RE: **McMahon Carwash**
McMahon and Fineland NW
Grading Plan Stamp Date: 8/17/18
Drainage Report Stamp Date: 8/17/18
Hydrology File: A11D016A

Based on the submittal received 8/13/18 and updated information provided on 8/17/18, the Grading Plan and Drainage Report are approved for Preliminary Plat and Building Permit.

RE: **McMahon Carwash**
McMahon and Fineland NW
Grading Plan Stamp Date: 6/20/18
Drainage Plan Stamp Date: 6/20/18
Hydrology File: A11D016A

Based on the submittal received 7/10/18, the Grading Plan and Drainage Report cannot be approved for until the following are corrected:

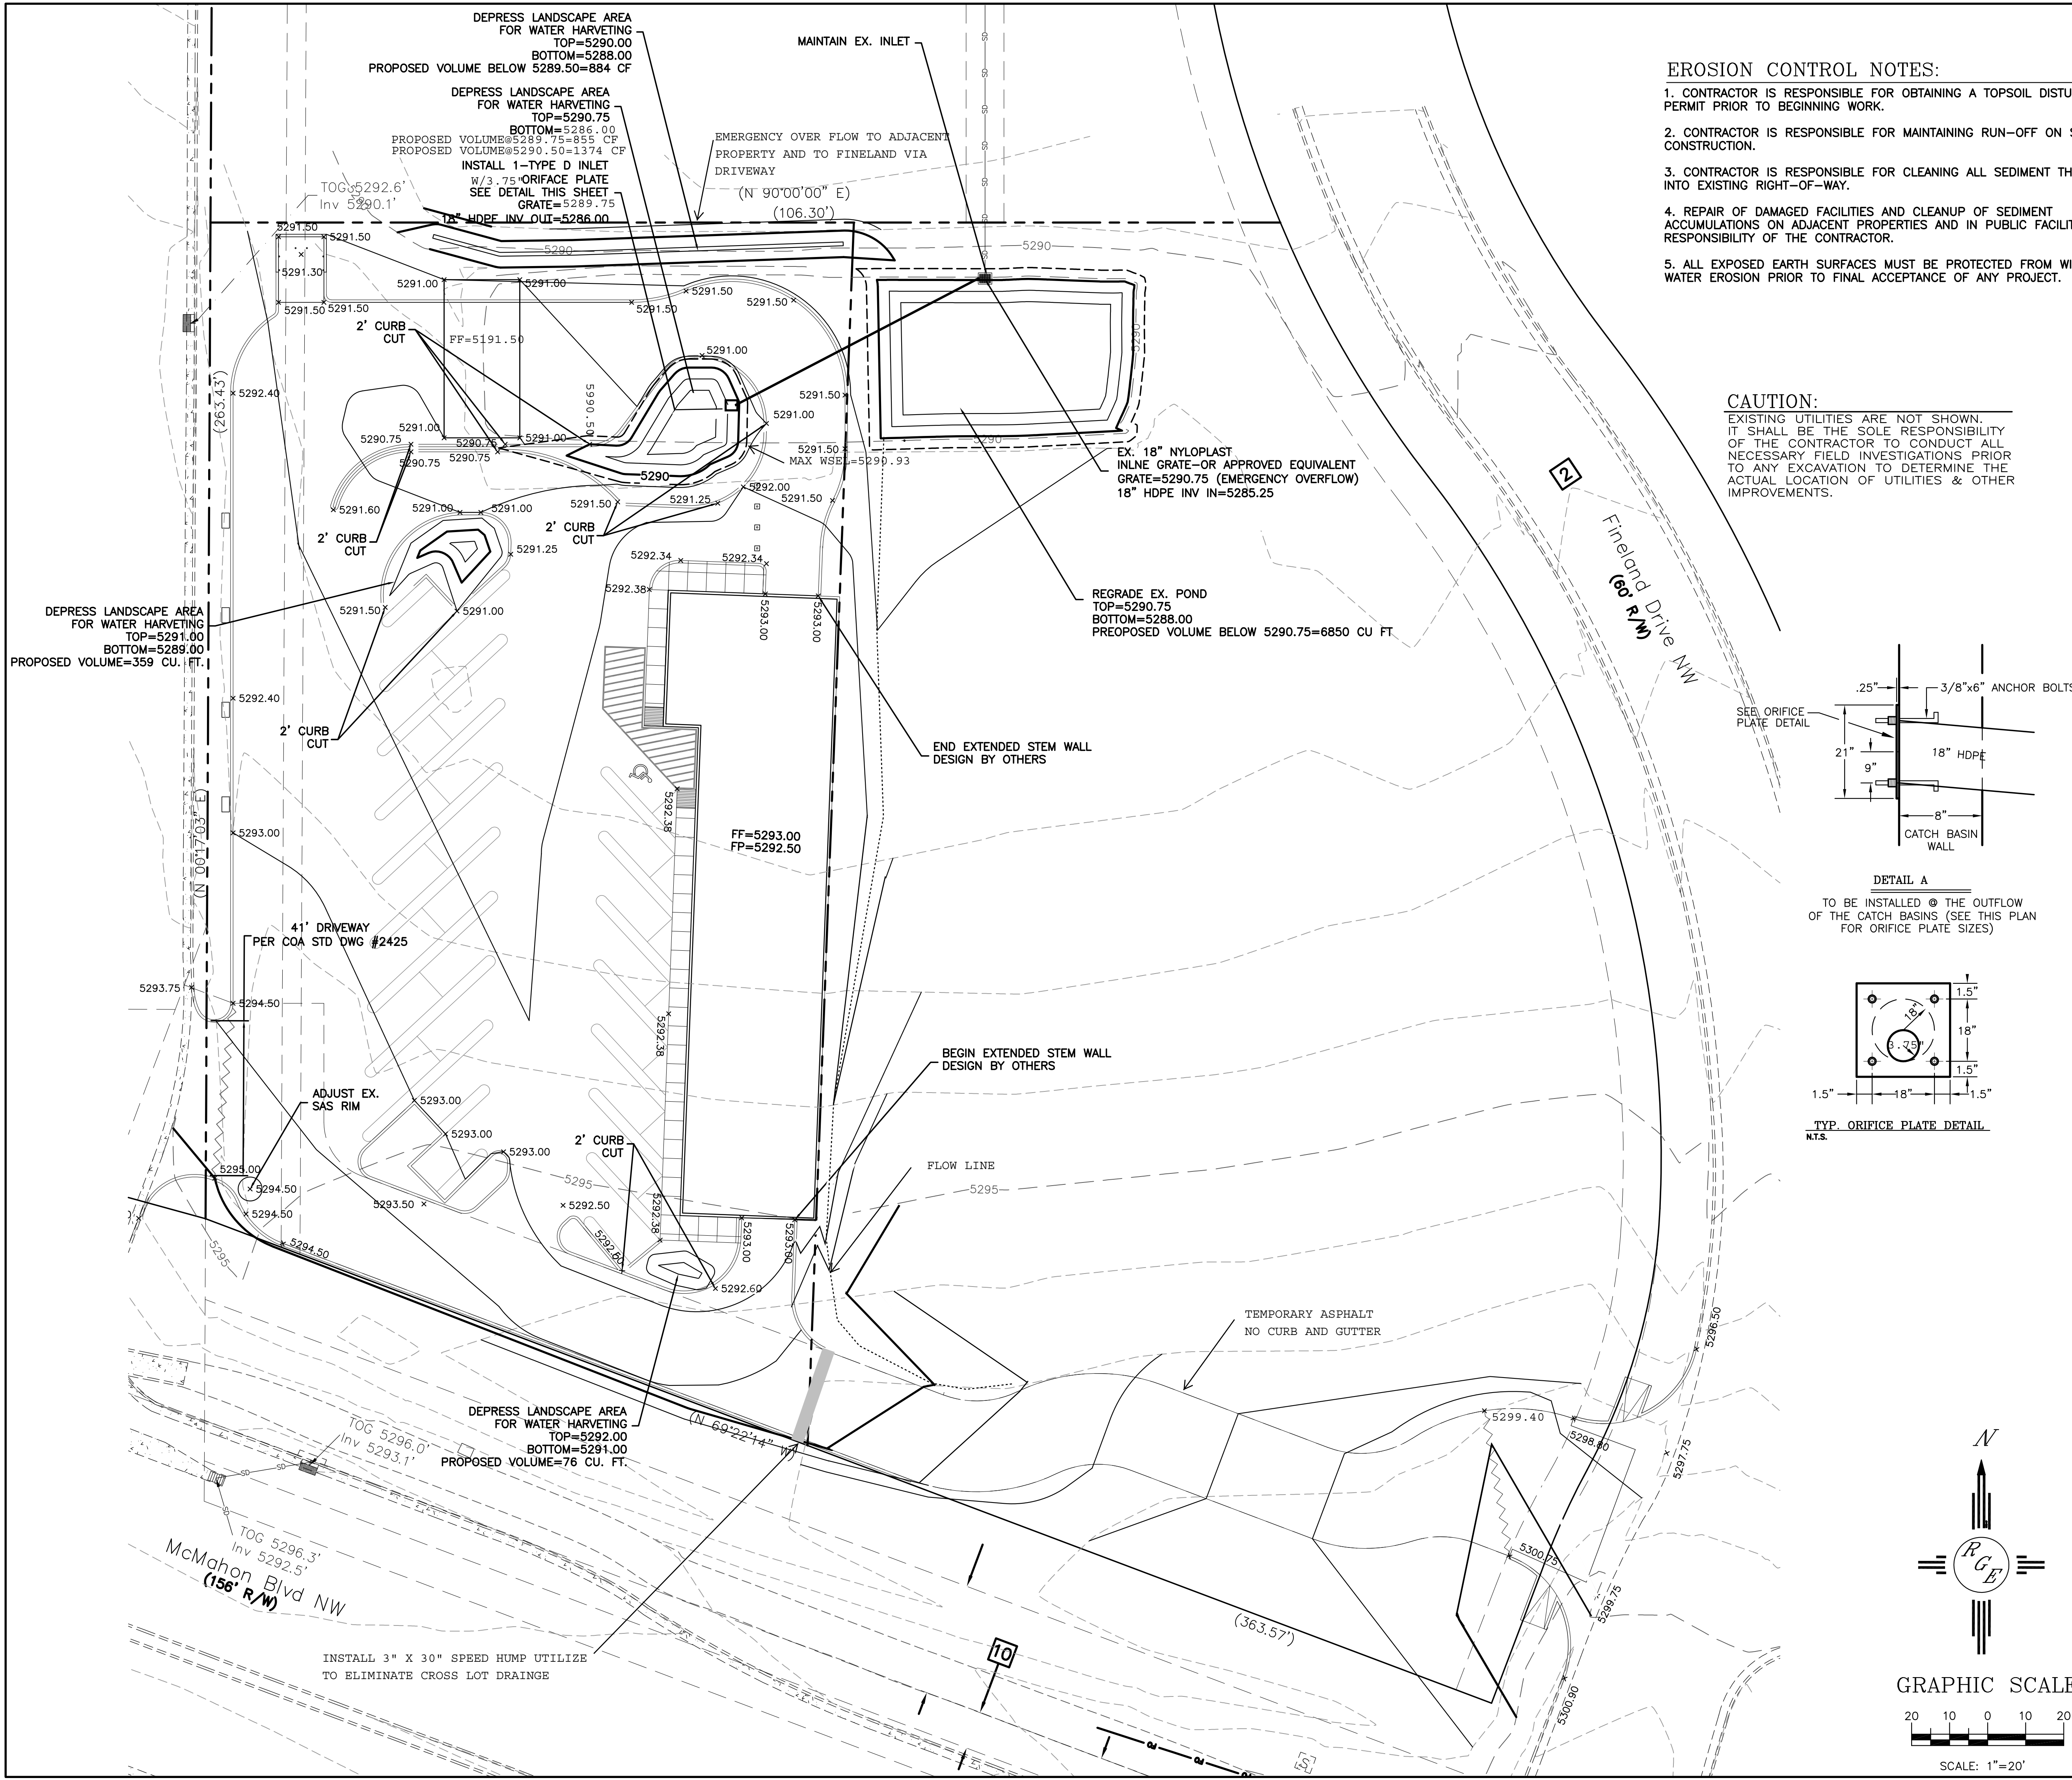
1. The first flush retention areas need to be clarified. The 4 small ponds in West Basin do not adequately capture the required volume. The north pond is higher than the parking lot and nothing seems to drain to it. The center pond has the grate elevation set at the bottom of the pond, so no dead storage is provided. The area draining to the 2 south ponds needs to be quantified, and the ponds sized to retain this first flush volume. **WE HAVE UPDATED POND TO CAPTURE FIRST FLUSH**

2. Provide minor contour labels and define spot elevations (top of curb, flowline, etc...). The spot elevations don't appear to agree with the proposed contours and it is difficult to see where the emergency overflows will go if the orifice plate clogs. **WE HAVE CORRECTED CONTOURS AND ADDED LABELS**

3. The elevations used in the volume calculations and orifice plate sizing (appendix B) do not match those on the grading plan. Please correct and show the max water surface elevation on the grading plan. **WE HAVE CORRECTED AND SHOWN MSWEL**
